**CONSOLIDATED RESPONSES TO CSPCWG LETTER 11/2009  
MISCELLANEOUS CHART SPECIFICATIONS**

<b>Submitted by:</b>	Chairman
<b>Executive Summary:</b>	Consolidated responses of WG members to Letter 11/2009 on new specifications requires a few decisions before final specifications are prepared for MS approval.
<b>Related Documents:</b>	S-4, INT1.
<b>Related Projects:</b>	None

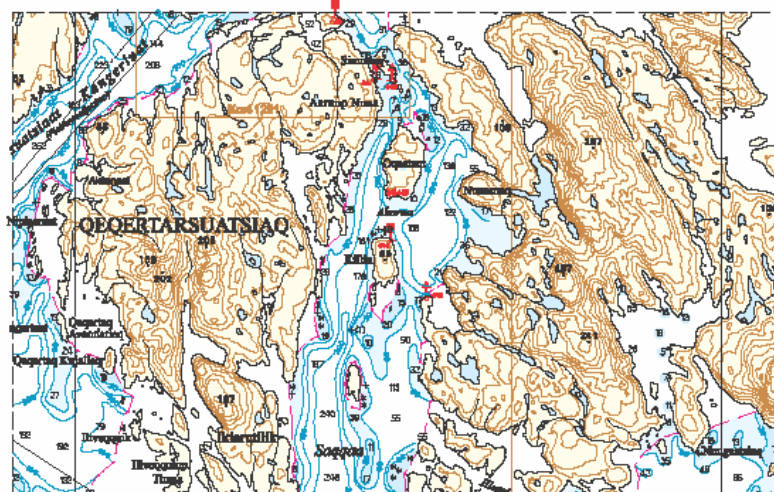
ACTION 11: We favour the Latvian way of portraying depths/obstructions under bridges, preferably in connection with examples G and/or H.

**Ask DK to explain this comment. G & H do not have depths?**

**Ask LV to explain what the tiny tint circles imply – what happens if the shoal is entirely under the bridge?**
